SCHEMATIC — BLOCK PLAN, CONCEPT ENVELOPE

LEVEL 1 — OVERALL FLOOR PLAN (REV K)

PROJECT Hazel Green Regional Athletic Complex Trojan Horse Arena · Hazel Green area, Madison County, Alabama (site TBD, D-006)	PHASE PHASE 2	SHEET TITLE OVERALL FLOOR PLAN LEVEL 1 · BLOCK PLAN	SCALE 1" = 40'-0"	DATE October 2026	REV K	DRAWN BY Drawn by Claude (AI) for Shane Brazelton	SHEET P2-A-101
--	-------------------------	---	---------------------------------------	---------------------------------------	-----------------	---	------------------------------

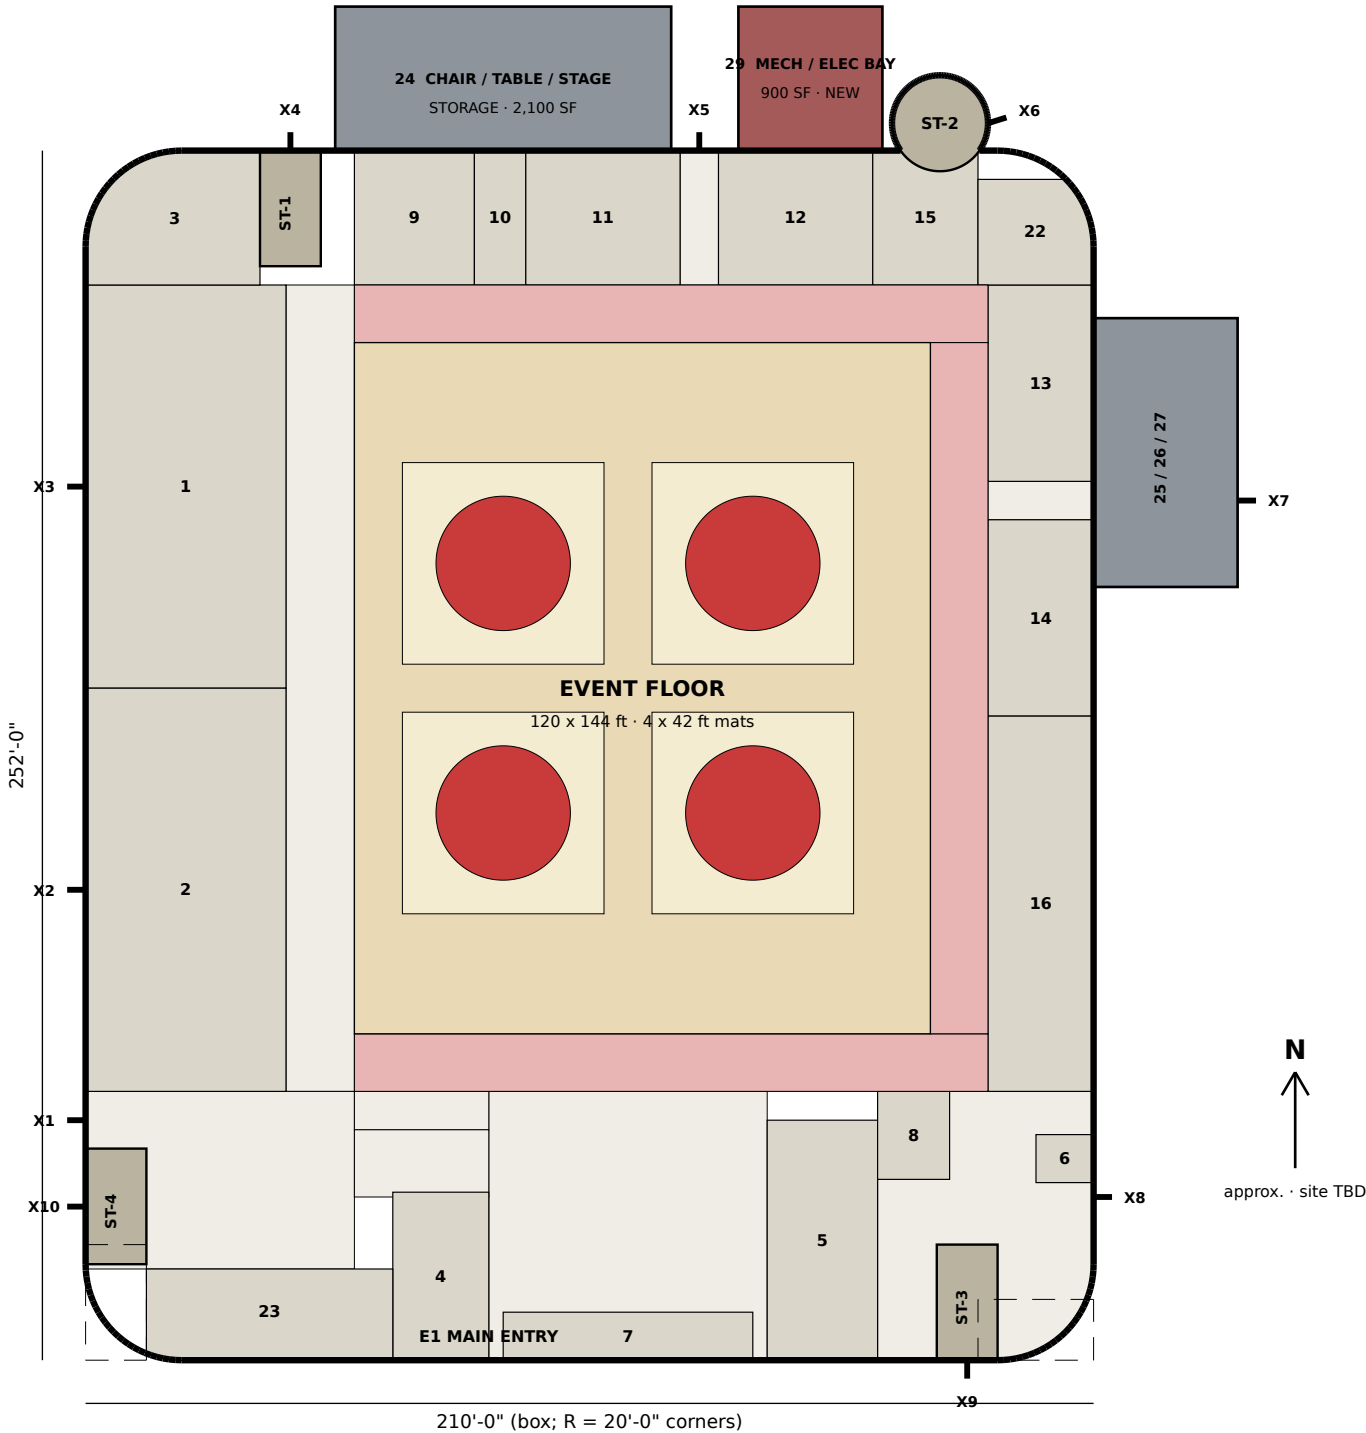
CHANGES FROM REV J (all ASSUMED)

- Envelope: 210 x 252 ft box with R = 20 ft corners (removes about 344 SF per level at the four corners).
- ST-3 (SE) slides west along the south wall to x 177.3-190; same 12.667 x 24.083 ft, exit X9 to x 183.7. Clears L2 WOMEN (2).
- ST-4 (SW) slides north along the west wall into the FLEX / TEAM ASSEMBLY zone (no program); exit X10 on the west wall; exit X1 moves to y 50 beside it.
- ST-2 (NE) is a 20 ft diameter cylindrical tower INSIDE the building envelope: the outline wraps it, it lands on the L2 loop north leg, exit X6 on its east face. Replaces the 24.08 x 6.67 ft NE projection.
- NEW 29 MECH / ELEC BAY 30 x 30 ft (900 SF), one storey, metal-building pop-out 14 ft east of the storage annex so the EXIT (N) passage at X5 stays clear (D-074).
- MECH (NW) and MECH (NE) lose corner area to the radius (below); the bay makes it up.

TAG	ROOM	REV J	REV K	CHANGE
3	MECH / ELEC (NW)	1,017	931	-86
22	MECH (NE)	530	505	-25
23	FLEX / STORAGE	975	972	-3
29	MECH / ELEC BAY (new)	0	900	+900
